802.3cg 10SPE AdHoc

Half-duplex and Precision Time Protocol(PTP)

# 802.3cg D3.1 comments #90 & #91

Figure 148-2—PLCA functions within the Reconciliation Sublayer (RS)

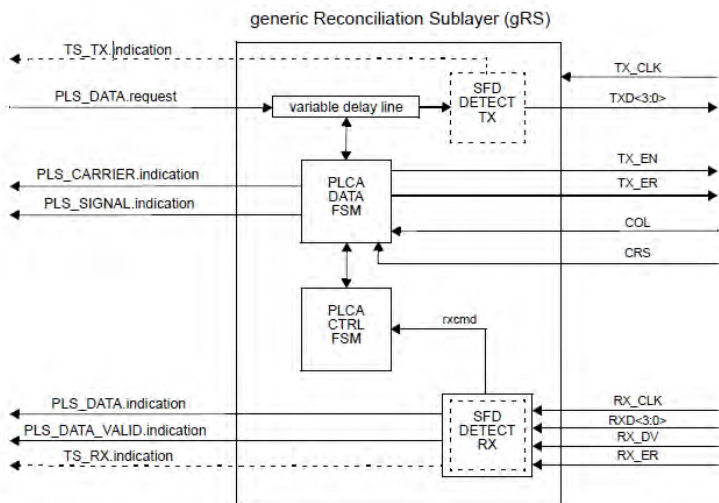
91	Jones, Peter	Cisco Systems, Inc.	148	148.4.2	235	10	TR	802.3cg should support the TSSI. I don't believe that the TF discussed the pros/cons of supporting PTP or decided not to support PTP on 10BASE-T1S half-duplex point to point or multidrop. A significant portion of the applications for 10BASE-T1S will need precision time support.	<p>Modify "Figure 148-2--PLCA functions within the Reconciliation Sublayer (RS)" to add TS_TX.indication, TS_RX.indication, SFD DETECT TX and SFD DETECT RX as shown in D2.0 Figure 148-3.</p> <p>Insert the following paragraph before "148.4.3 Mapping of MII signals to PLS service primitives and PLCA functions"</p> <p>"Operation with TSSI</p> <p>When TSSI support is also specified in the actual RS, the SFD detection of transmitted frames shall be detected after the PLCA variable delay line, as shown in Figure 148-2. This ensures the network latency measurement is not affected by the synchronization latency added by PLCA. No special attention is required for SFD detection of received frames."</p>

Modify "Figure 148-2--PLCA functions within the Reconciliation Sublayer (RS)" to add TS\_TX.indication, TS\_RX.indication, SFD DETECT TX and SFD DETECT RX as shown in D2.0 Figure 148-3.

When TSSI support is also specified in the actual RS, the SFD detection of transmitted frames shall be detected after the PLCA variable delay line, as shown in Figure 148-2. This ensures the network latency measurement is not affected by the synchronization latency added by PLCA. No special attention is required for SFD detection of received frames.

**When TSSI support is also specified in the actual RS, the SFD detection of transmitted frames shall be detected after the PLCA variable delay line, as shown in Figure 148-2. This ensures the network latency measurement is not affected by the synchronization latency added by PLCA. No special attention is required for SFD detection of received frames**
